Addendum Number: 02**Addendum Issue Date:** January 14, 2026**Owner:** Robinson-Palestine Water Commission**Project Name:** Water Treatment Plant and Campus**Project Number:** 0210007.00**Containing:** # Pages; # Drawings; # Specifications

12. SHEET C1 & C2 – PROVIDED as a standalone attachment with the addendum. These sheets pertain to Rte. 1 and Rte. 33 watermain crossing. These sheets were included in the original specifications, as a permit attachment for the aforementioned crossings. The attached sheets with the addendum are a higher resolution version of the of the same sheets that were provided with the original specifications.

PROJECT:
**Robinson-Palestine Water
Commission**

Water Treatment Plant and Campus

- 1 08/16/2021 BASIS OF DESIGN REVIEW
- 2 10/21/2021 SITE UPDATE
- 3 01/05/2026 ADDENDUM #2

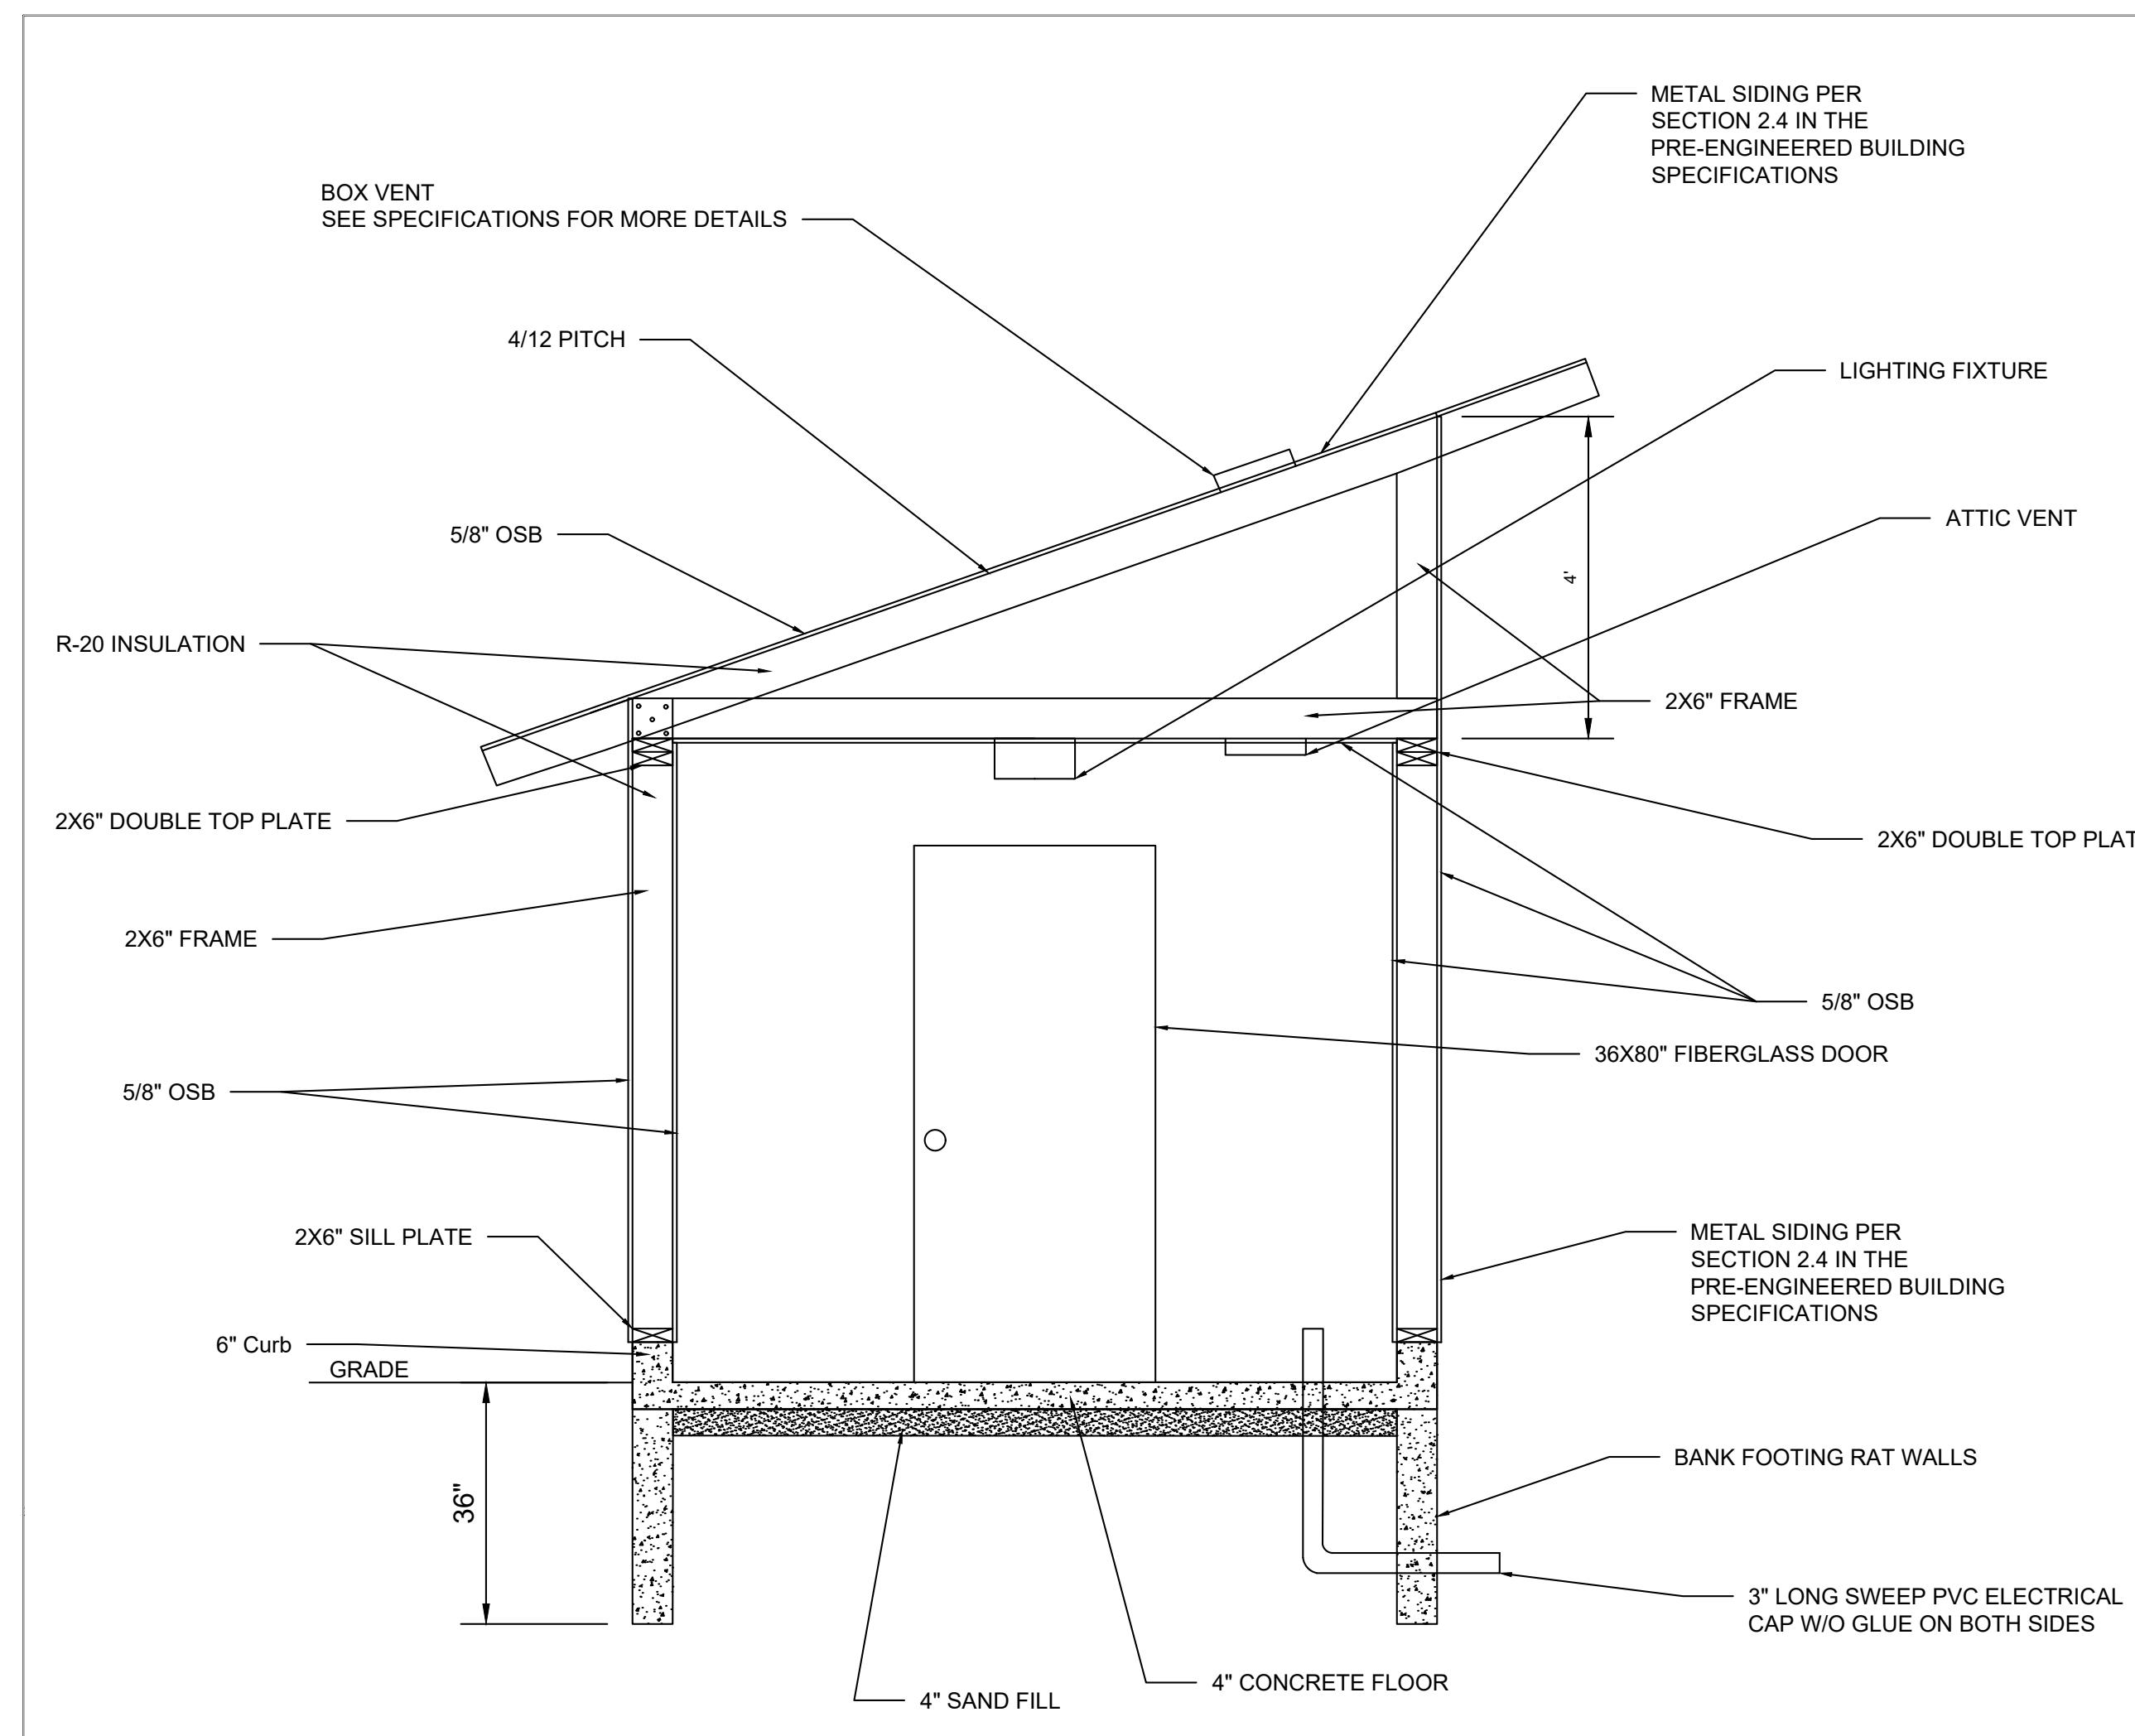
14. SHEET C5.1 TO SHEET 5.3 – ADDED details about VFD Shed for the existing wells, to be included with this contract.

B. AT EACH EXISTING WELL MOVE EXISTING VFD CABINET TO NEW VFD SHED. PROVIDE CONDUIT AND CONDUCTOR FROM EXISTING WELL HOUSE TO NEW VFD SHED TO RE-FEED VFD AND PUMP. PROVIDE LIGHTING AND POWER AS SHOWN ON PLAN SHEETS.

- C. 6" CONCRETE CURBS WILL BE POURED IN ADDITION TO THE CONCRETE FLOOR FOR THE FRAME OF THE BUILDING TO BE BUILT ON.
 - D. SIX 3" CONDUITS WILL BE RAN THROUGH THE FOOTINGS AND UP THROUGH THE FLOORS OF THE BUILDING. LOCATION OF CONDUIT WILL BE SUSCEPTIBLE TO CHANGE BASED ON LOCATION OF THE SHED RELATIVE TO THE WELLS.

- B. PROVIDE LITHONIA LIGHT FIXTURE: CSS L48 7000LM MVOLT MIN10 ZT 35K 80CRI NLIGHT PIR ZACVH M100.
 - C. THE ATTIC VENT WILL BE A BROAN ROOMSIDE SERIES 110 CFM CEILING EXHAUST BATH FAN. MODEL NO: AR110.

SHEET TITLE: **UTILITY PLAN**

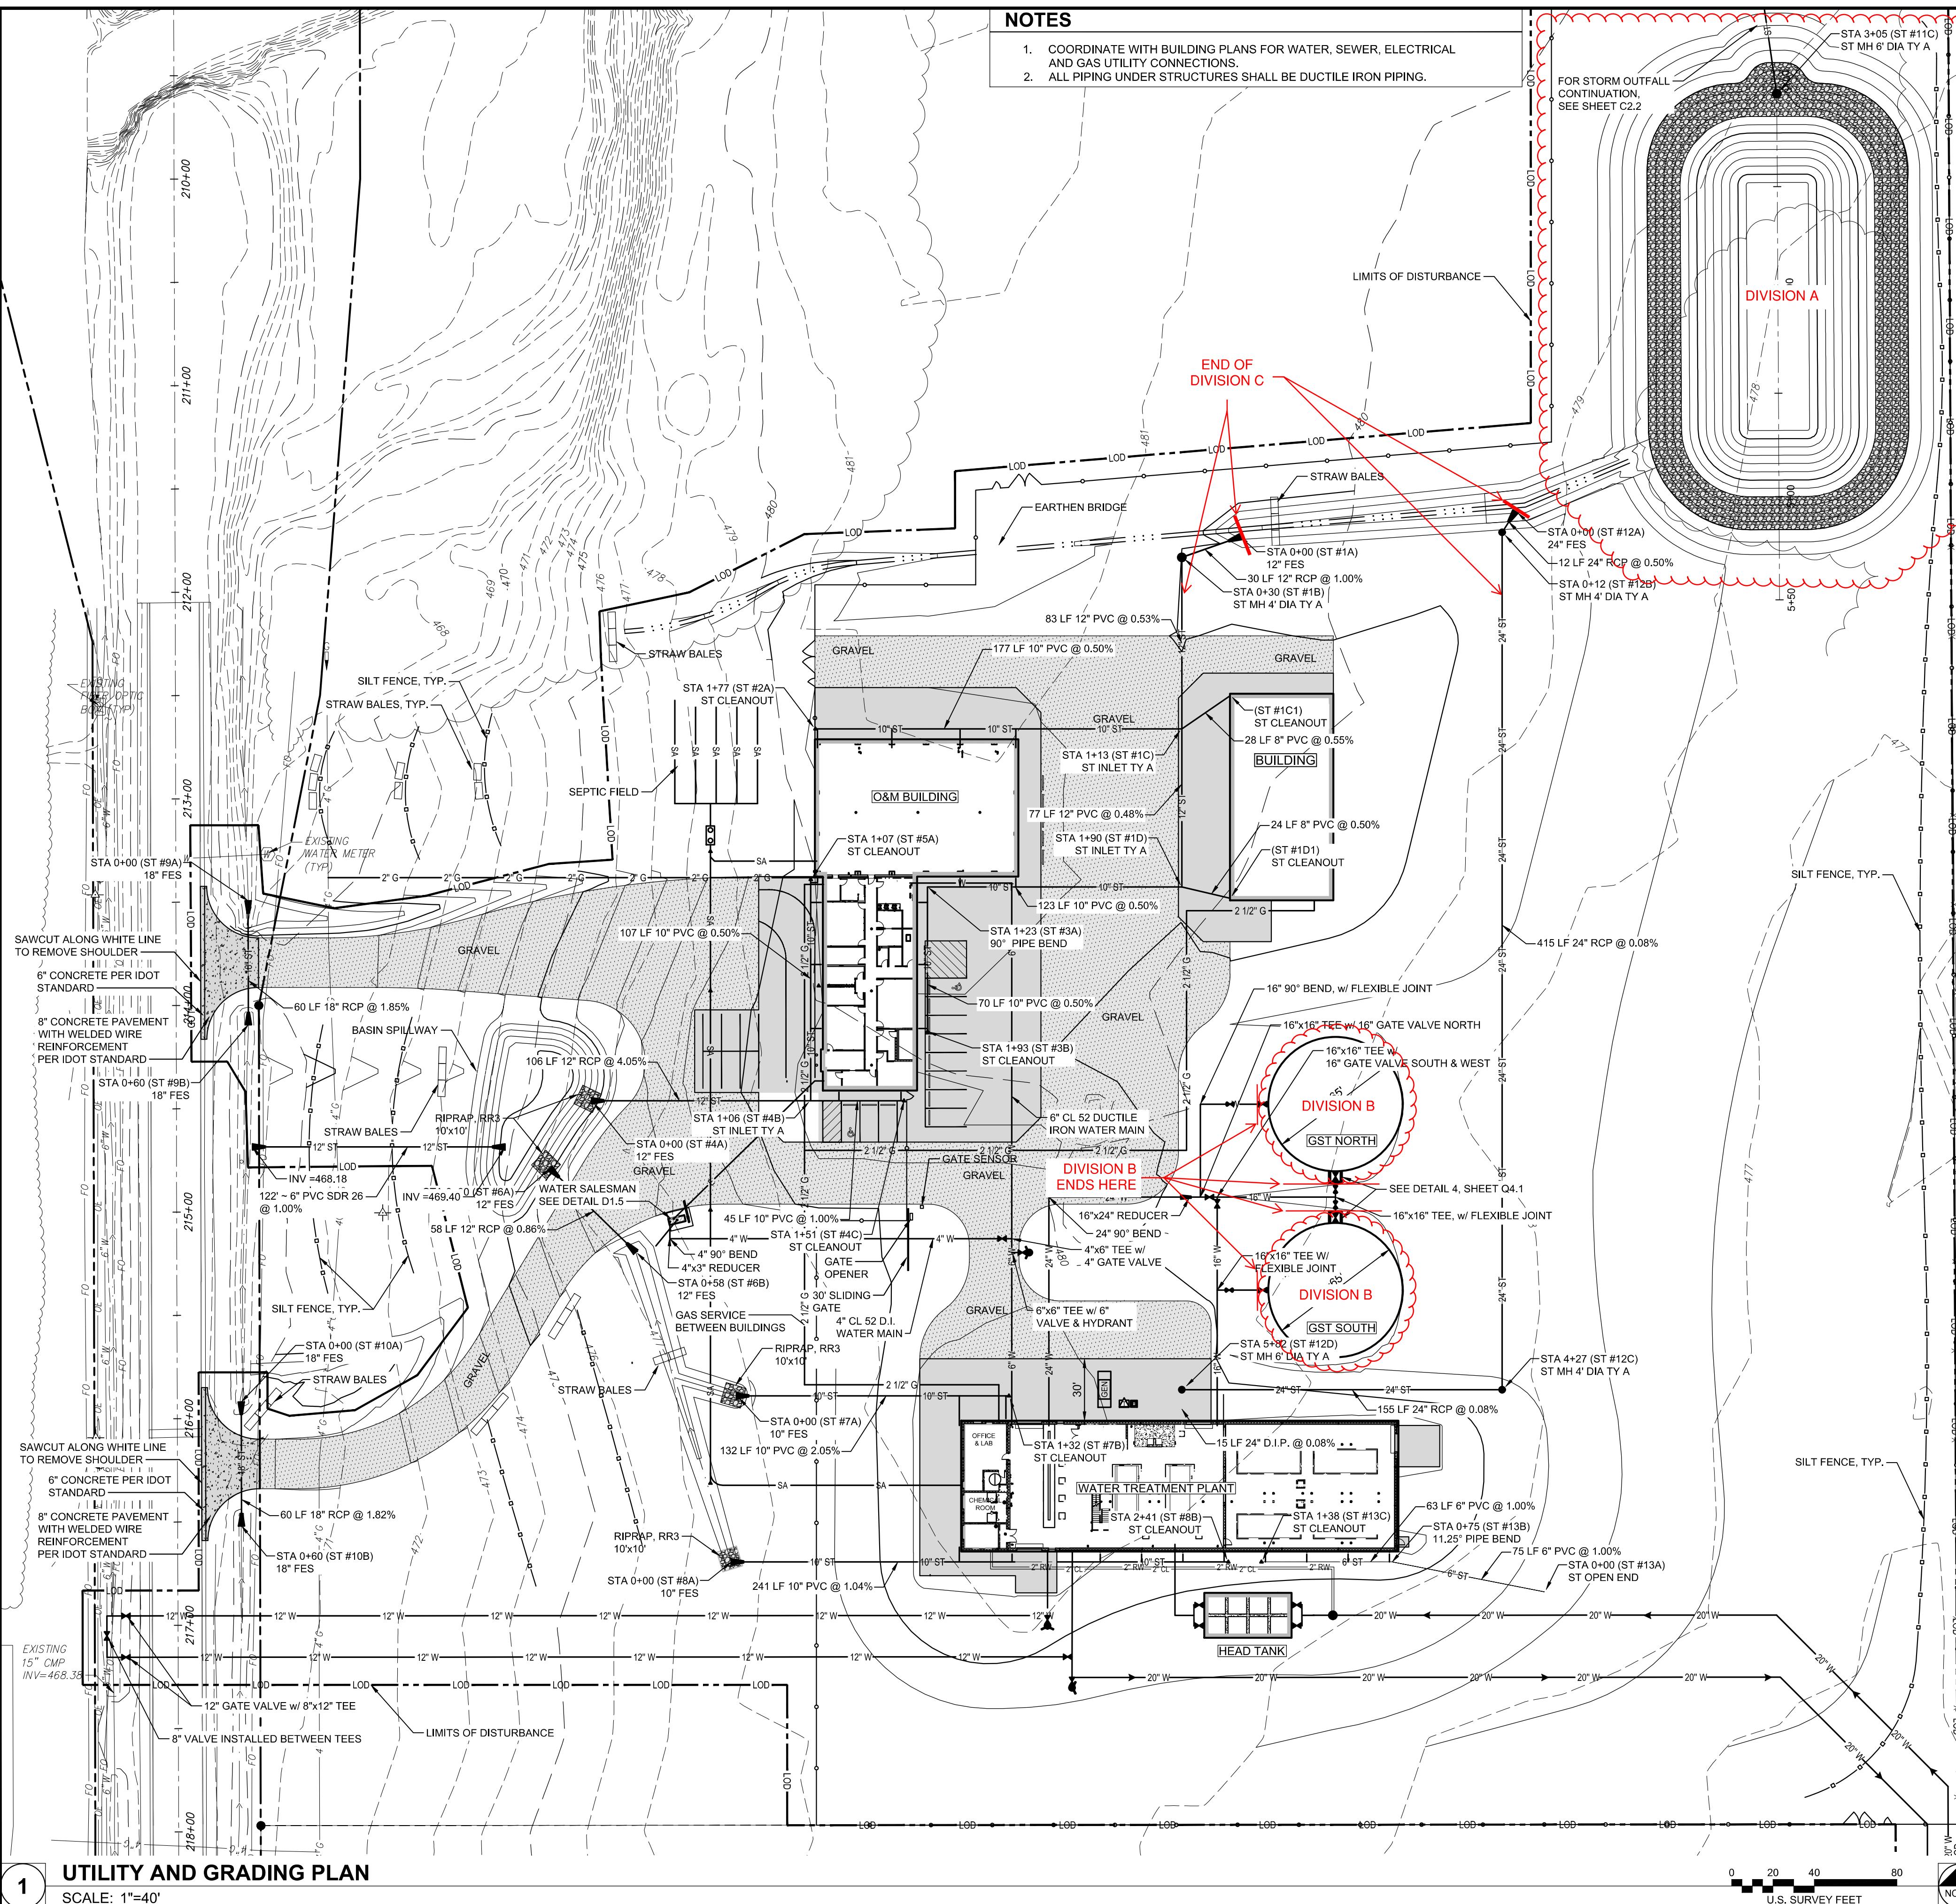
17. On sheet C1.1, north of the Storage and O&M buildings, there appears to be a swale that drains east to the basin. At the outlet of the swale there are two parallel lines with intermittent groups of 3 dots running westerly until they terminate at some straw bales. What are these parallel lines with dots? I don't see a legend with comparable designation.
